**ADDENDUM NO. 3 TO PROJECT NO. 42534-E**

**ELECTRICAL WORK  
UPGRADE ELECTRIC DISTRIBUTION SYSTEM, SITEWIDE  
GREAT MEADOW CORRECTIONAL FACILITY  
ROUTE 22  
COMSTOCK, NY 12821**

November 10, 2014

MARK	DATE	DESCRIPTION
△	11-03-14	ADDENDUM NO. 3
△	10-27-14	ADDENDUM NO. 1
	12/27/13	BD DOCUMENTS
PROJECT NUMBER:	42534-E	
DESIGNED BY:	GDPH	
DRAWN BY:	GDPH	
FIELD CHECK:	GDPH	
APPROVED:	AHT	
SHEET TITLE:	ELECTRICAL DISTRIBUTION PROFILES	
DRAWING NUMBER:	E-311

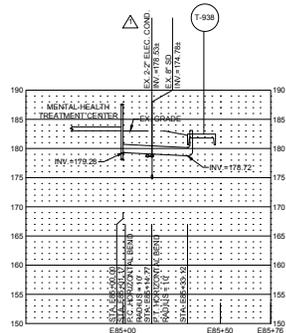
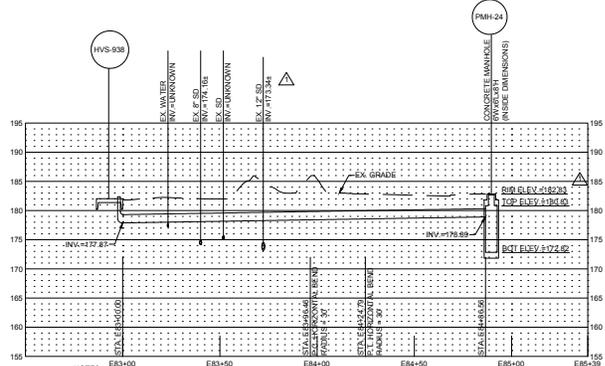
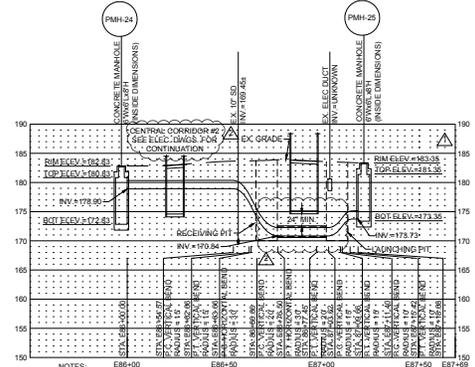
- 5. Revised Drawings:
  - a. Drawing Nos. E-311, E-401B and E-504, noted “11/03/14 ADDENDUM NO. 3” accompany this Addendum and supersede the same numbered originally issued drawings and same numbered previously issued Addendum drawings.
  - b. Drawing Nos. E-402B and E-503, noted “11/03/14 ADDENDUM NO. 3” accompany this Addendum and supersede the same numbered originally issued drawings.
- 6. Drawing No. G-003, GENERAL NOTES:
  - a. Add the following GENERAL NOTE:
    - “13. INCLUDE IN THE CONTRACT BID PRICE THE REMOVAL AND DISPOSAL OF 500 CUBIC YARDS OF SOUND BEDROCK. SEE SPECIFICATION SECTION 312316 OF THE PROJECT MANUAL FOR VOLUME DETERMINATION AND REMOVAL REQUIREMENTS.”
- 7. Drawing No. E-501, DETAIL 2/E-501:
  - a. PRE-CAST MANHOLE INSTALLATION DETAIL: Change “WATERPROOFING” to read “DAMPPROOFING”.
